Remarks:

10/624,310; 07/22/2003
ANNOTATED MARKED UP DRAWINGS

FIG. 2C

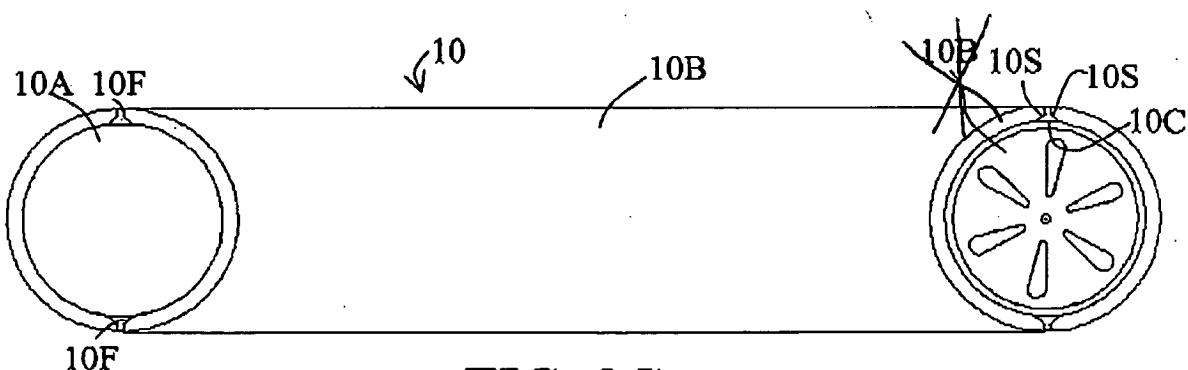
6. **Amendments to the Drawings:** Examiner objected to the drawings for failing to call out certain features on the drawings. Reference designations have been added to FIGS. 5A, 5B, and 9 to properly call out all features described in the Specification. Reference designations were also corrected on FIGS. 2C, 8, and 9. No new features were added to any of the figures and, thus, no new subject matter introduced with these amendments. Accordingly, Applicant requests that the amended drawings be approved and entered.

FIG. 6

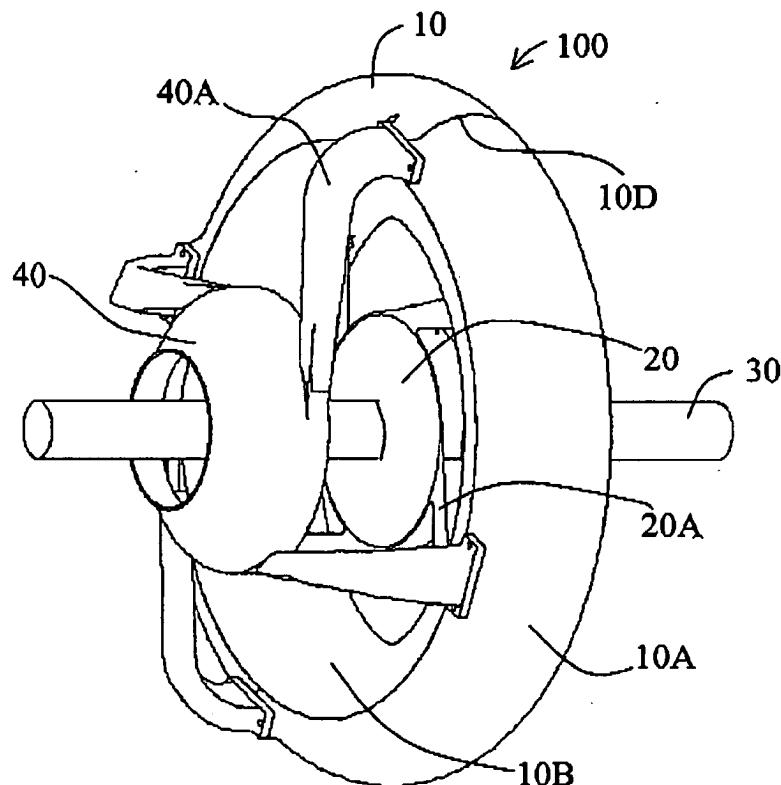
7. **Rejection of Claims 22 and 23 under 35 U.S.C. § 112:** Applicant submits that the amendments to claims 22 and 23 remove this enablement rejection. FIG. 6 and 9 show the engine mounted on the shaft. Applicant requests that examiner withdraw this rejection of claims 22 and 23 and allow these claims.
